PROPOSED CHANGE TO LCO 4.2.7 AND LCO 4.2.9
AND BASIS

Specification LCO 4.2.7 - PCRV Pressurization Limiting Conditions for Operation

Specification LCO 4.2.9 - PCRV Closure Leakage, Limiting Conditions
for Operation

SAFETY ANALYSIS SUPPORTING PCRV AUXILIARY PIPING SYSTEM MODIFICATION
AND OPERATION FOR THE STEAM GENERATOR PENETRATION INTERSPACES

LOOP II SHOWN (LOOP I TYPICAL)

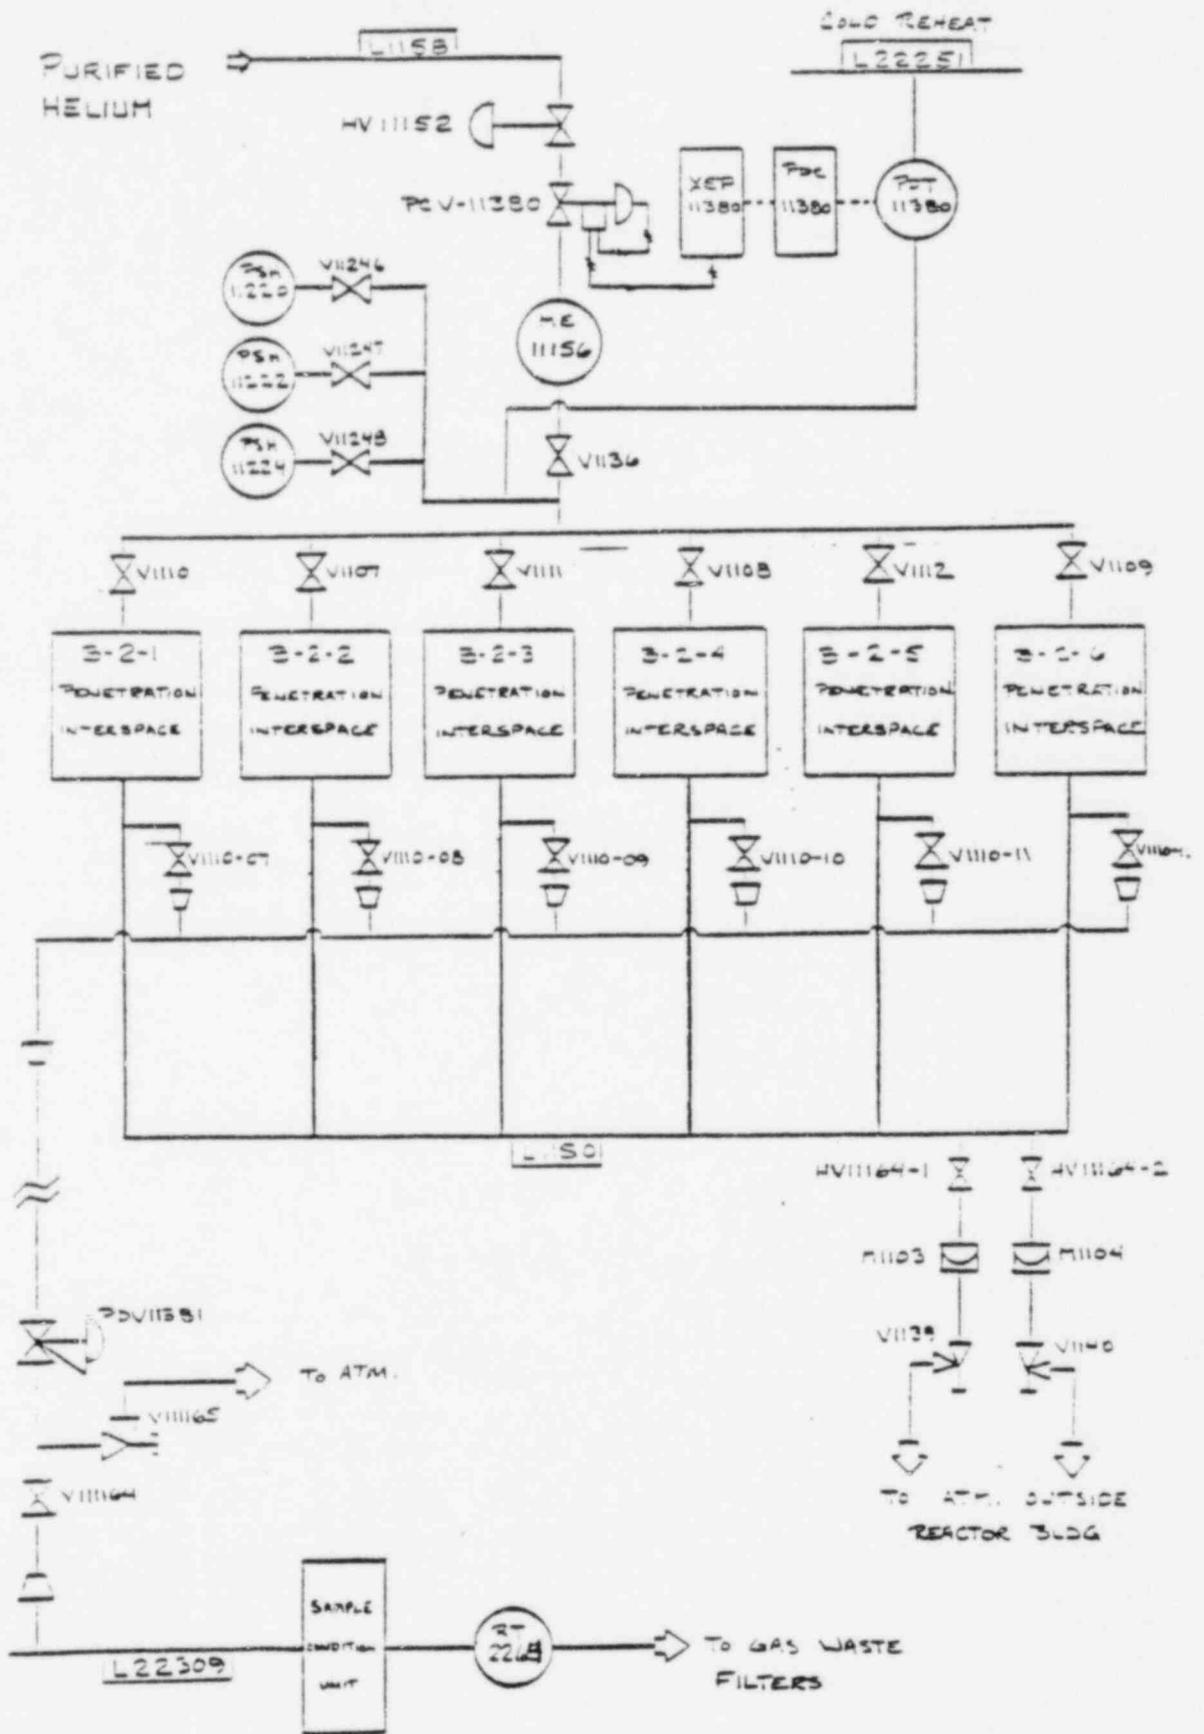
The PCRV auxiliary piping system for the steam generator penetration interspaces has been modified as shown in the attached sketch. Pressure control valves PCV-11379 and PCV-11380 have been added on the inlet side for each steam generator loop. This permits the penetration interspaces for either or both steam generator loops to be maintained above cold reheat steam pressure or above primary coolant pressure as the situation requires. Sample lines have been added to each module penetration interspace, and in turn routed to activity monitors 2263 for Loop 1 and 2264 for Loop 2. Each sample line contains an individual flow control/block valve. Normally, these activity monitors will be sampling all penetration interspaces that are being maintained below primary coolant pressure, but above cold reheat steam pressure. However, the interspace gas from each penetration can be separately directed to the activity monitor for diagnostic testing. The discharge flow from the activity monitors will be routed to the gas waste system. All other features of the PCRV auxiliary piping system for the steam generator penetration interspaces remain unchanged by this modification.
